VILLAGE OF ARLINGTON HEIGHTS
STAFF DEVELOPMENT
COMMITTEE REPORT

File Number: PC #17-016
Project Title: Sigwalt Apartments/CA Ventures
Address: 37-45 S. Chestnut St., 36-40 S. Highland St.
PIN: 03-30-425-021 thru 023, 03-30-425-012 thru 014

To: Plan Commission
Prepared By: Sam Hubbard,
 Development Planner
Meeting Date: February 28, 2018
Date Prepared: February 23, 2018

Map I – Subject Property and Adjacent Comprehensive Plan Land Designations

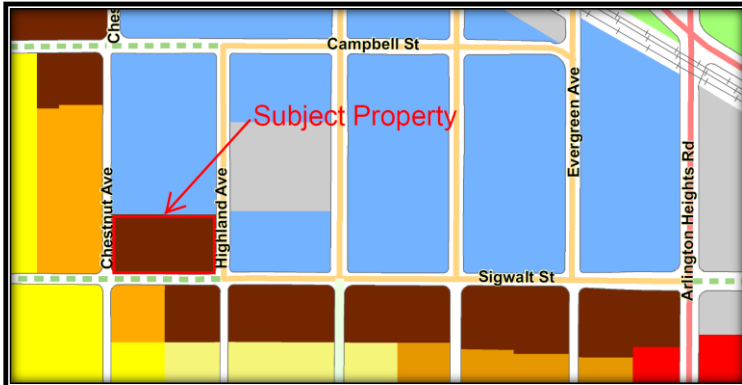
One of the variations relates to the size of the R-7 Zoning District, which in this instance will be 1.39 acres where code requires a minimum of 2 acres for land within the R-7 District. Therefore, the following variation is needed:

The minimum R-7 district size is primarily intended to limit instances of spot zoning on smaller properties that may be contiguous with the B-5 District. However, the Comprehensive Plan designates the site as one part of a larger strip of R-7 zoned land that is contiguous to the subject property, and when considered in sum, this strip of potential R-7 zoning is well over two acres in size. **Map I** (below) illustrates this area, with the subject property outlined in red, the

brown areas indicating properties appropriate for the R-7 District, and the blue properties as appropriate for B-5 Downtown District zoning:

When the vision of the Comprehensive Plan is realized, the subject property will no longer be an isolated pocket of R-7 zoning and the variation will no longer be applicable. Additionally, this property is unique in that in order to comply with the Comprehensive Plan designation of “High-Density Residential”, R-7 zoning is required and a variation is needed. For these reasons, the Staff Development Committee is supportive of the requested variation.
